INCH-POUND
MIL-H-83511/4B
AMENDMENT 1
15 October 1999

MILITARY SPECIFICATION SHEET

HEADSET-MICROPHONE
H-161F/GR

This amendment forms part of Military Specification Sheet MIL-H-83511/4B, dated 10 February 1992, and is approved by all Departments and Agencies of the Department of Defense.

Alternate locking thumbnut configuration.

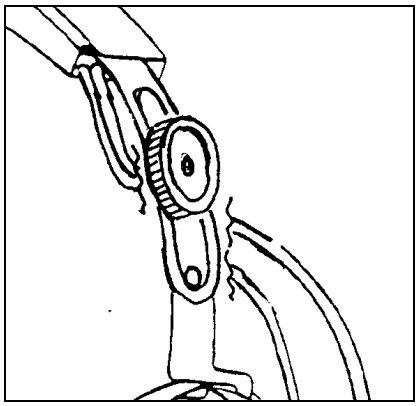
FIGURE 1: Add to Figure 1a & 1b Alternate configuration to the sliding action is a positive locking thumbnut.
